U.S. NUCLEAR REGULATORY COMMISSION

Report Nos. 50-361/90-37, 50-362/90-37
Docket Nos. 50-361, 50-362
License Nos. NPF-10, NPF-15
Licensee: Southern California Edison Company
Irvine Operations Center
23 Parker Street
Irvine, California 92718
Facility Name: San Onofre Units 2 and 3
Inspection at: San Onofre, San Clemente, California
Inspection conducted: October 1, 1990 through November 15, 1990
Inspectors: A. L. Hon, Resident Inspector
C. W. Caldwell, Senior Resident Inspector
Approved By: P. H. Johnson 12/3/90
P. H. Johnson, Chief Date Signed
Reactor Projects Section 3

Inspection on October 1 through November 15, 1990 (Report Nos. 50-361/90-37, 50-362/90-37)

Areas Inspected: This is a special resident inspection of Units 2 and 3 operations program elements involving two licensee-identified Technical Specifications violations that involved misalignment of valves and resulted in the inoperability of important safety equipment. One violation affected the emergency core cooling (ECCS) and containment spray (CS) sub-systems and the containment integrity in Unit 3. The second violation affected the auxiliary feedwater system in Unit 2. Inspection procedures 30703, 61726, 71707, 71710,

FIGURE 1

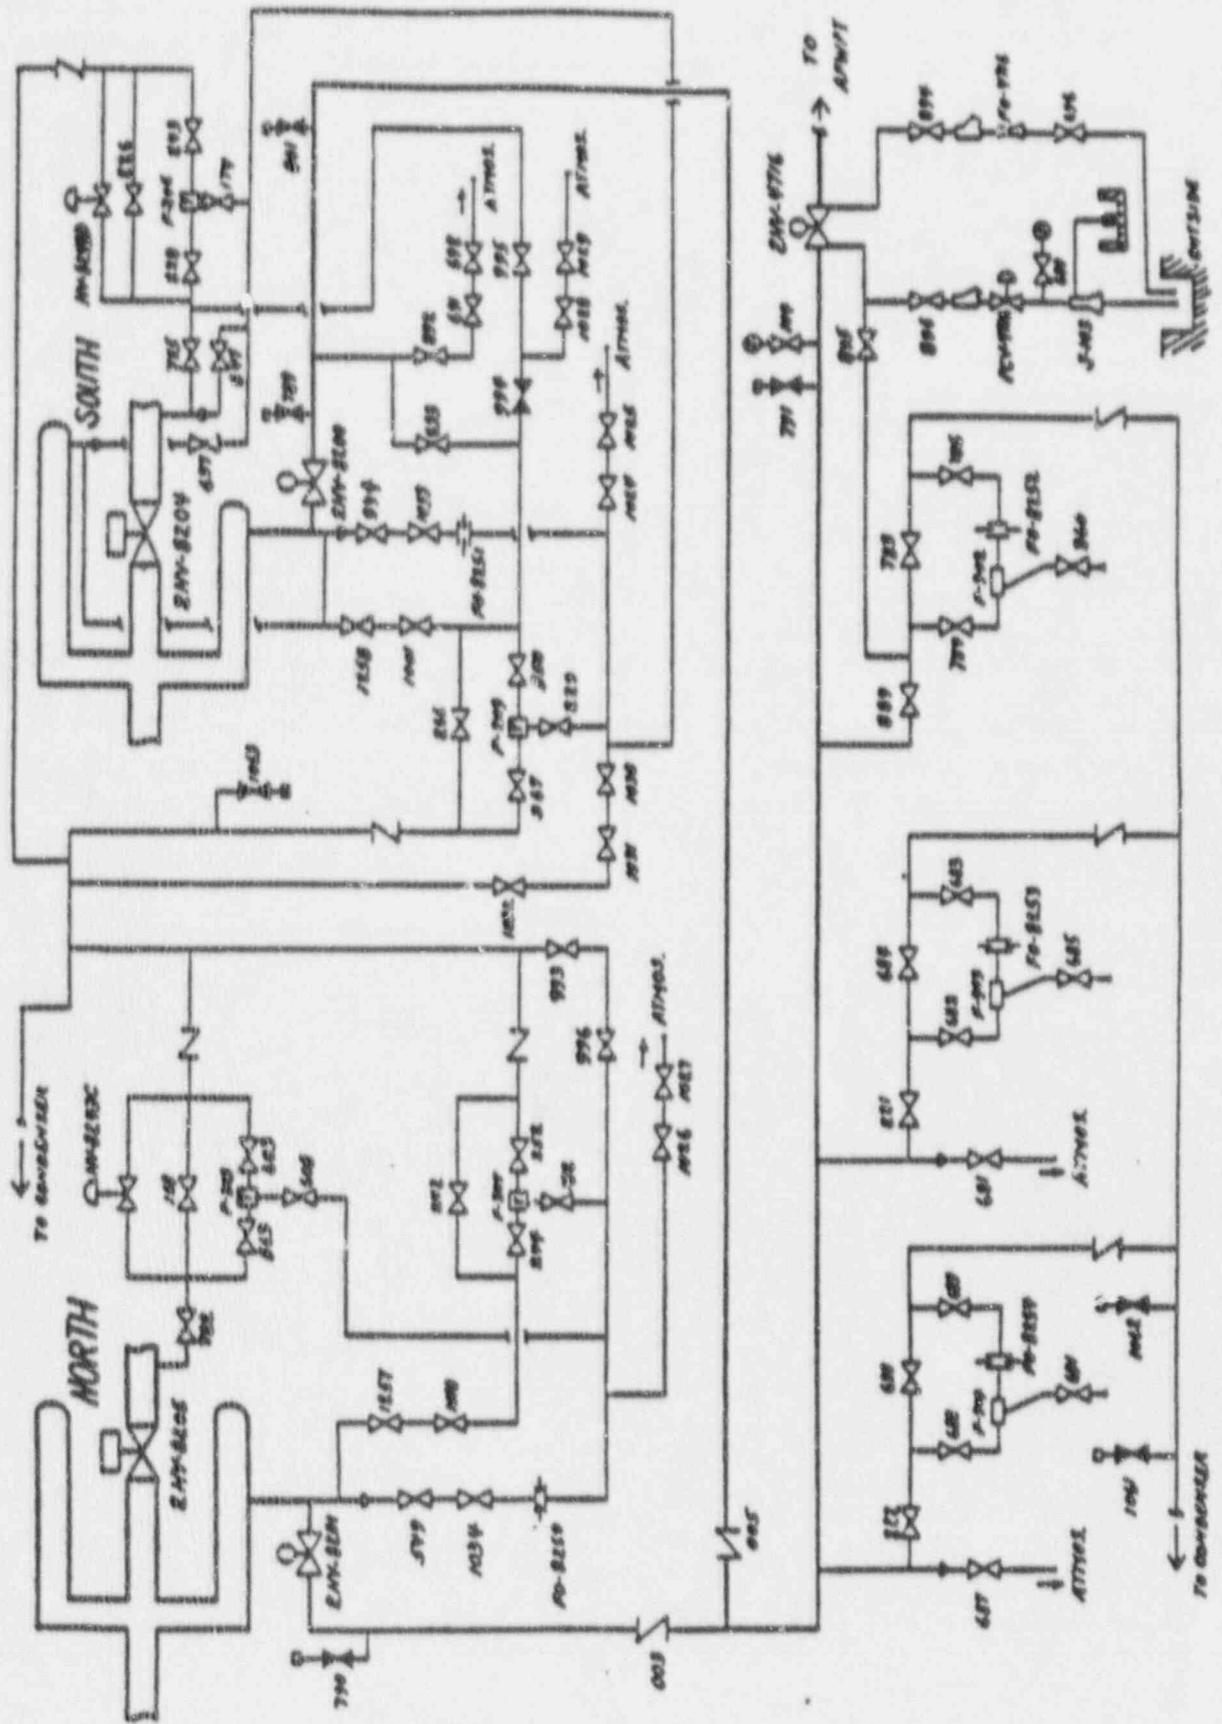
- Steam supply (from SG E-088) isolation valve 2HV-8201 is normally closed to limit wear on check valve S21301MU003, caused by pressure differential between the two steam generators. (Refer to Figure 1, enclosed with this report).
- Continuous condensate removal lines are connected upstream and downstream of steam stop valve HV-4716. (Figure 1)
- Overspeed trip was set at 110% of the 3570 RPM nominal speed.
- Applicable T.S. requirements while in Modes 1, 2, and 3:
 - 3.7.1.2, Actions a and b:
 - one pump inoperable - 72 hour shutdown
 - two pumps inoperable - 6 hour shutdown
 - 3.1.1.1, Action c.2:
 - with one EDG and P-140 Inoperable - 6 hour shutdown

- Another missed opportunity occurred during the troubleshooting between October 6 and 21, 1990 when P-140 tripped three times due to overspeed. Although the condensation in the steam line was identified as a potential candidate, the engineer requested that Operations check the alignment without a clearly defined scope of the boundary. As a result, the steam trap alignment check was inadequately performed. Operations checked the alignment up to HV-8200 and HV-8201 -- an artificial boundary which is downstream of MU1258 and MU1257.

- Equipment operators failed to identify MU-1257 as being closed on their rounds, even though it is in a fairly prominent location.
- The overspeed trip setpoint was set at 110% of the nominal operating speed of the pump. This left the pump with a relatively narrow margin to respond to condensation in steam supply lines. The vendor believed that 125% would assure sufficient margin, while still providing proper overspeed protection.
